**AGENDA
TECHNICAL REVIEW COMMITTEE (TRC)
May 6, 2025
10:00AM**

**MINUTES
TECHNICAL REVIEW COMMITTEE (TRC)
April 1, 2025
10:00AM**

**RE: SWC-23 AMERICAN AUTO RV & BOAT STORAGE (AVO 043866.157)
MAJOR SITE PLAN REVIEW #2**

**RE: GRIFFIN PRESERVE PRELIMINARY PLAT (AVO 043866.154)
REVIEW #2**

SHEET
C-3.00

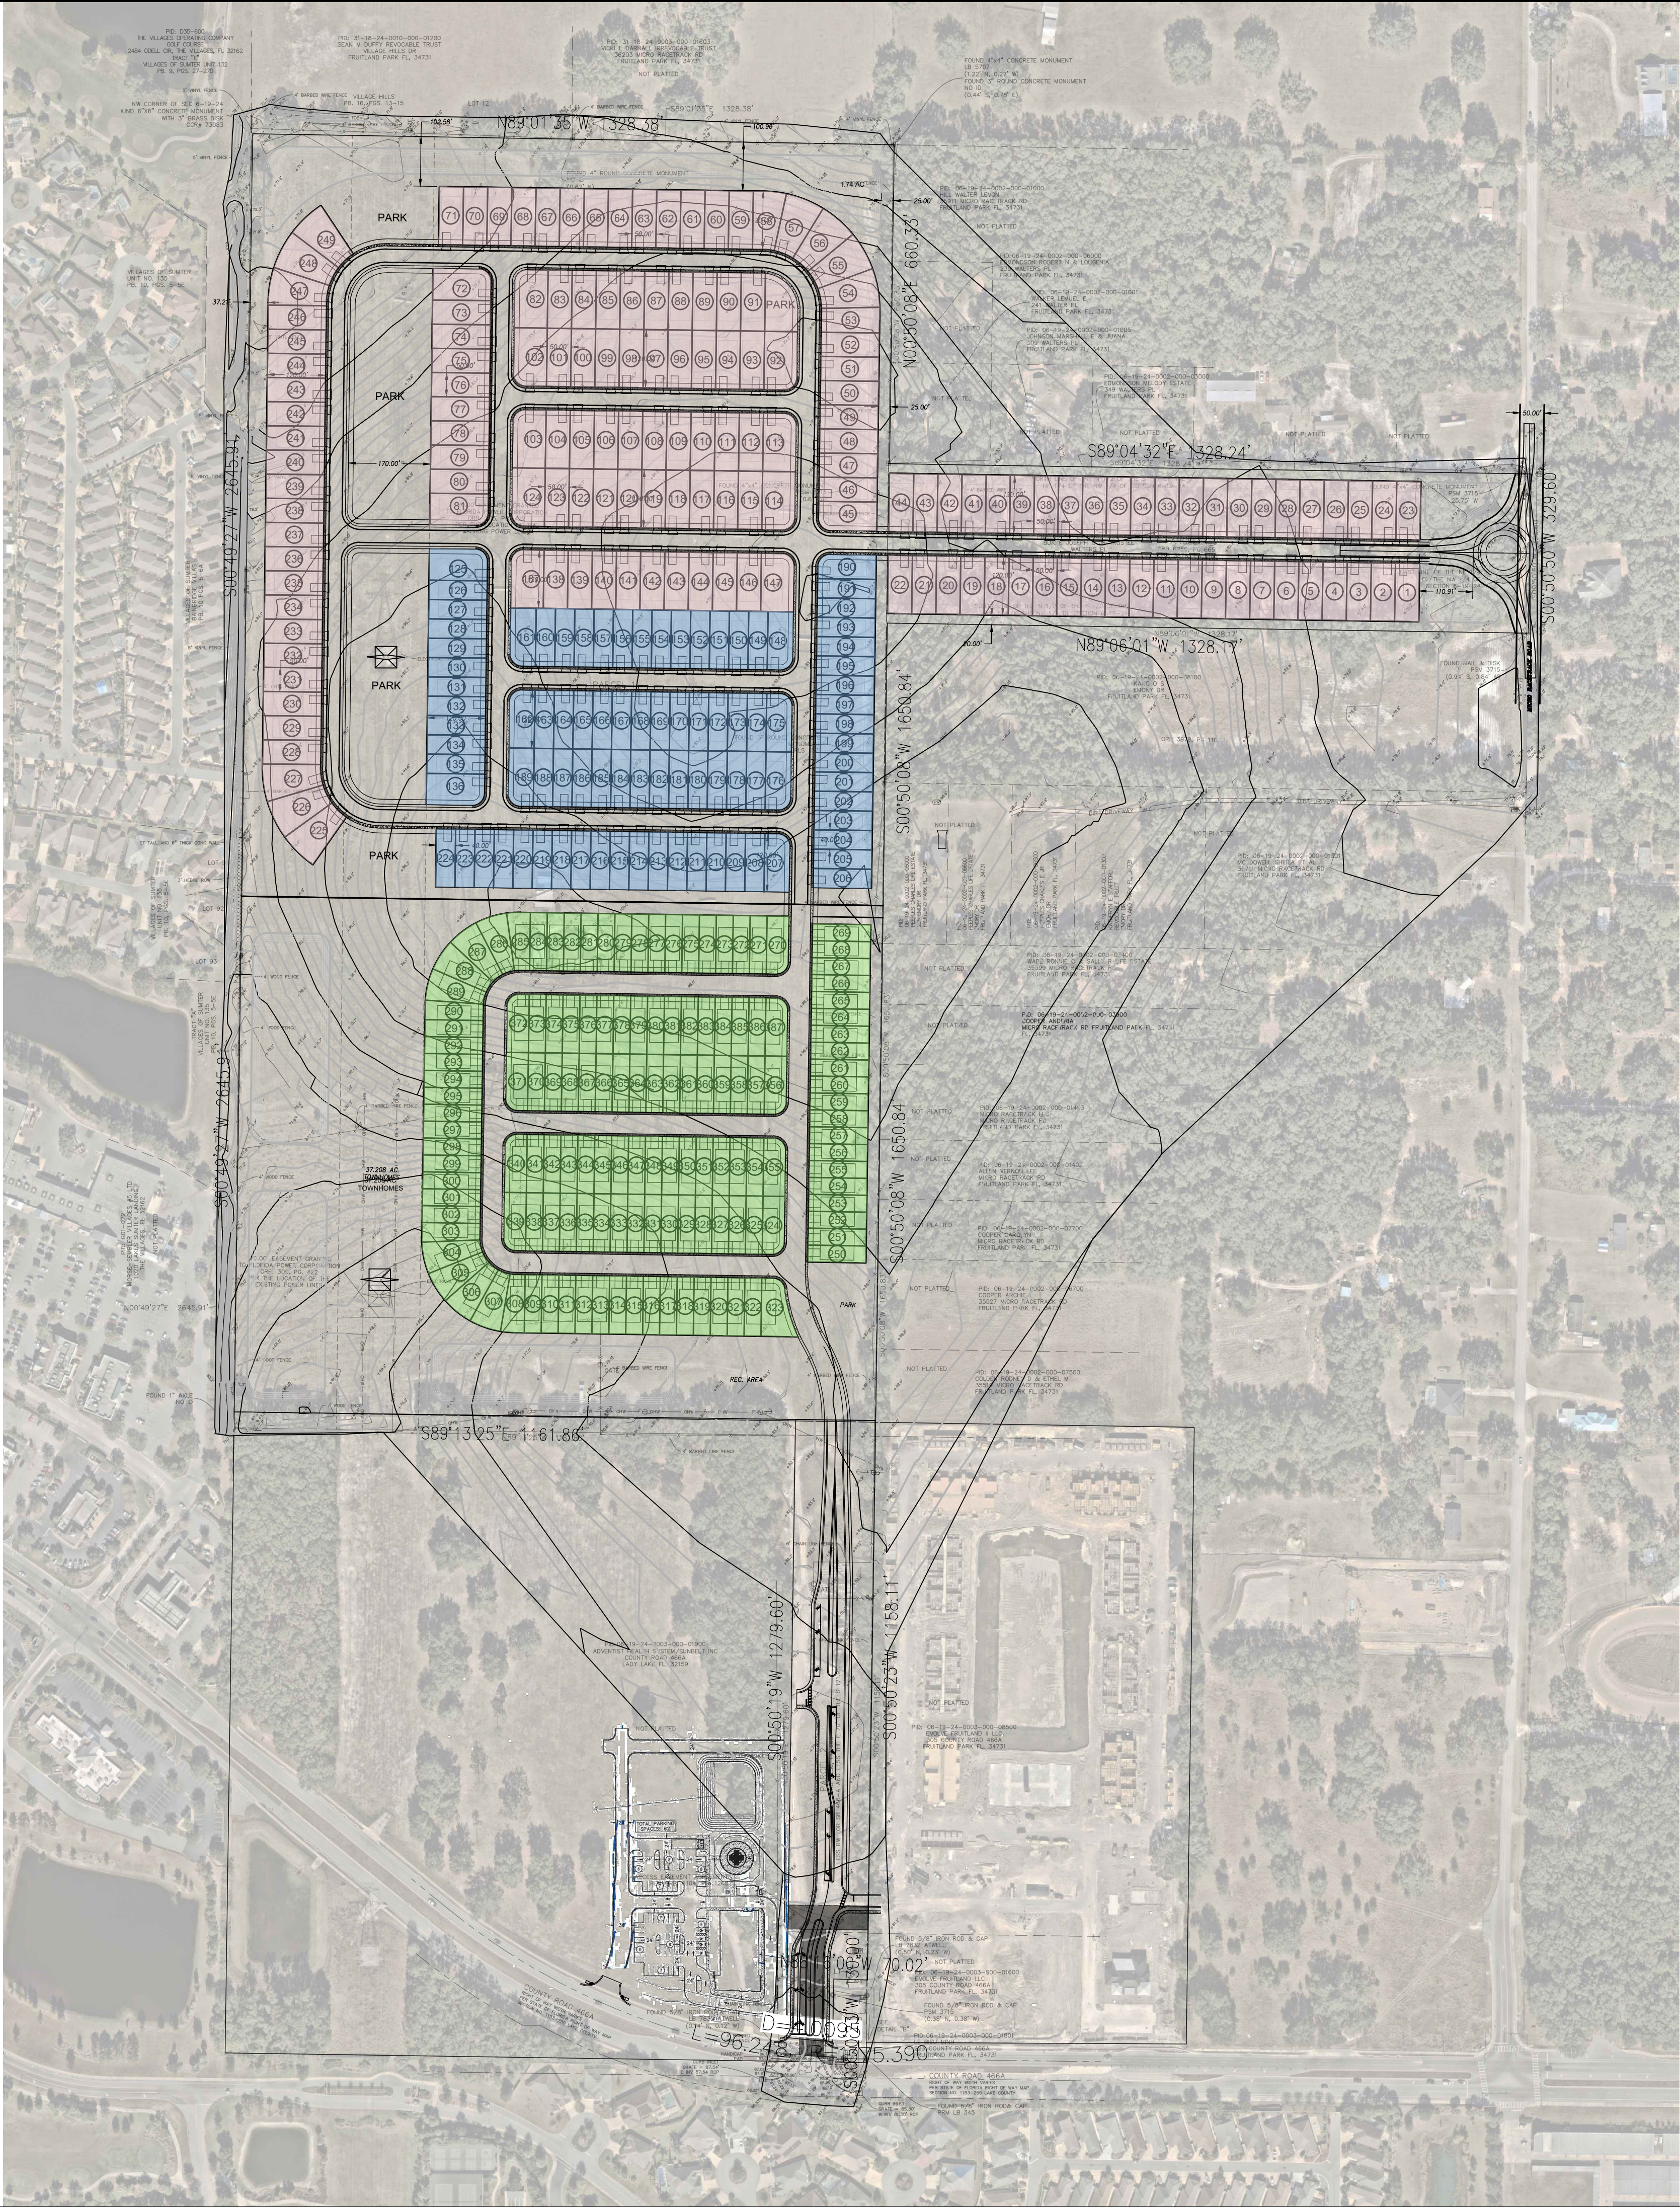
- a. For example, setbacks only given for Single Family lots, none given for Multi-Family lots on C-3.00.
17. Provide the web soil survey report with the general delineation provided. (154.030, d, 11, G, ii, i)
